**CITY OF ST. PETERSBURG  
PLANNING & DEVELOPMENT SERVICES DEPT.  
DEVELOPMENT REVIEW SERVICES DIVISION**

**DEVELOPMENT REVIEW COMMISSION  
STAFF REPORT**

CASE NO.: 20-31000006 PLAT SHEET: F-3, F-5

REQUEST: Approval of a Site Plan modification to allow construction of a steam and chilled water above ground utility system in the EC-2 zoning district. The applicant is requesting variances for: 1) Ancillary equipment visible from the street and 2) Encroachment into the required visibility triangles.

Sheet	of	5
Drawing No.	2A	
Scale	1" = 40'	
Date	11/15/2017	
Author	JLW	
Checker	JLW	
Drawn	JLW	
Revised

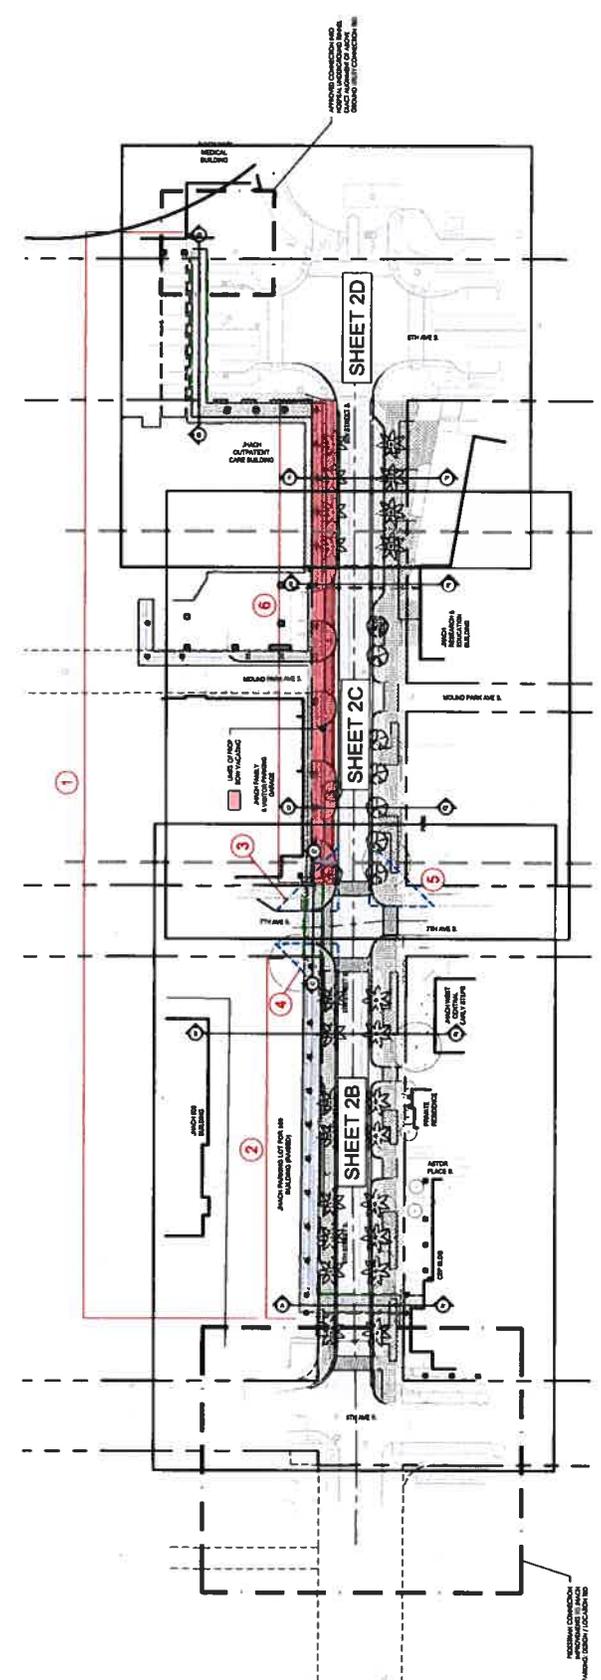
<b>2</b>	<b>Visibility Triangle – along 5<sup>th</sup> Street South</b>
<b>Required:</b>	<b>45 feet</b>
<b>Proposed:</b>	<b>20 feet</b>
<b>Variance:</b>	<b>25 feet</b>

The columns that support the above ground utility, including the three-foot tall planters that are at the base of the columns and the proposed street trees encroach into the visibility triangle. The support columns, planters and street tree encroach into the 45-degree visibility triangles at the northwest and southwest corner of 5<sup>th</sup> Street South and 7<sup>th</sup> Avenue South, and a street tree encroaches into the 45-degree visibility triangle at northeast corner of 5<sup>th</sup> Street South and 7<sup>th</sup> Avenue South. The city code requires that no vegetation be allowed to grow higher than 36 inches and up to two trees with branches no lower than eight feet are allowed in the right-of-way of each street. Height shall be measured vertically from the pavement surface at the edge of the adjacent street.

This application requests a variance from Section 16.40.160.1.B.1 of the City of St. Petersburg's Land Development Regulations ("LDR"). This section of the City's LDRs regulates private property and rights-of-way in proximity to the intersections of streets, alleys and driveways in order to provide clear visibility for safe traffic through intersections. Structures, or vegetation that would grow more than 36 inches in height, are prohibited within "sight triangles" that are established by Section 16.40.160.1.B.1 of the City's LDRs at the intersection of streets, alleys and driveways. This variance request specifically pertains to the northeast corner of the intersection of 5th Street South and 7th Avenue South. At this location, above ground utility and streetscape improvements proposed along the 5th Street South corridor locate a street tree within the sight triangle formed by the northeast quadrant of the 5th Street South and 7th Avenue South intersection. These proposed intrusions that require this variance are shown on Sheet 2A of the revised JHACH Master Plan.
